CERTIFICATE OF APPROPRIATENESS

Property: 1710 Crockett St, Lot 3, Block 229, Baker NSBB Subdivision. The property includes a historic 1,142 square foot, one-story wood frame single-family residence situated on a 5,000 square foot (50' x 100') interior lot.

Proposal: Alteration – Windows/Porch

Recommendation: Partial Approval: Approval for replacement of porch columns/rails and removal of damaged rear chimney, denial for relocation of window

WEST SIDE ELEVATION

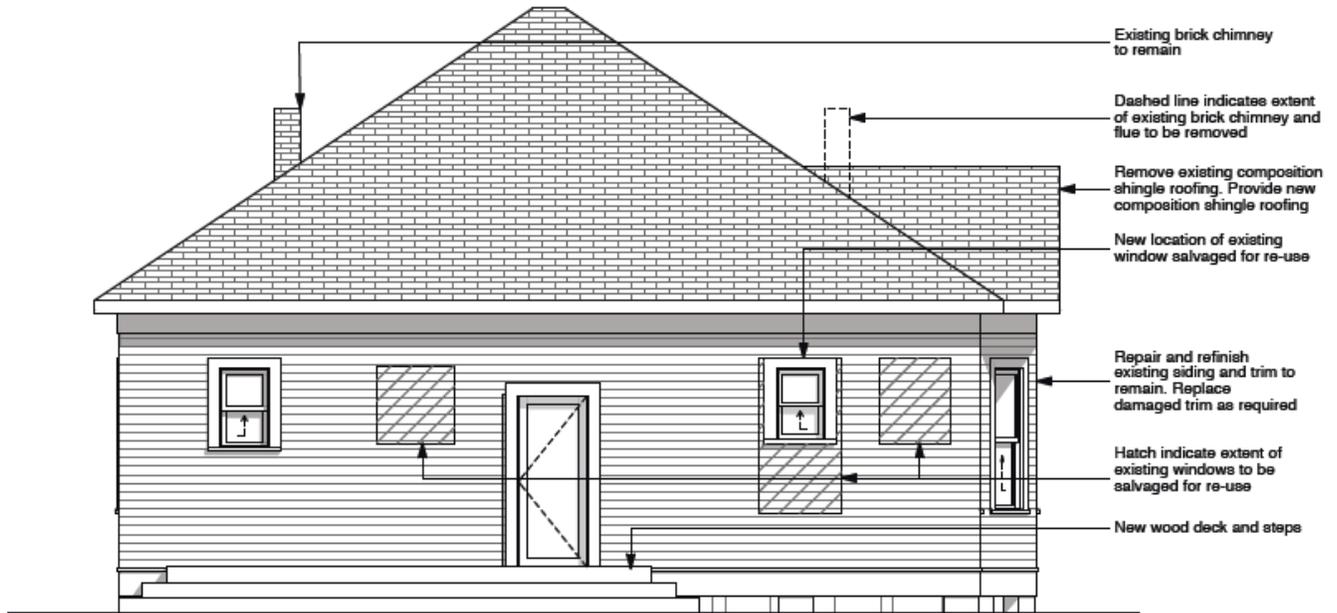
<i>Windows are key elements of the property's historical character and should be retained. Altering the original fenestration pattern diminishes the character of the property and should not be altered on the basis of an interior remodel.</i> |

<i>Windows are key elements of the property's historical character and should be retained. Altering the original fenestration pattern diminishes the character of the property and should not be altered on the basis of an interior remodel.</i> |

<i>The relocation of the window from its existing location destroys historic material through the removal of siding. The relocation also involves the unnecessary installation of new siding at the existing window's location. Relocating the window may also cause structural issues unforeseen at this time and cause the further alteration of the west elevation.</i> |
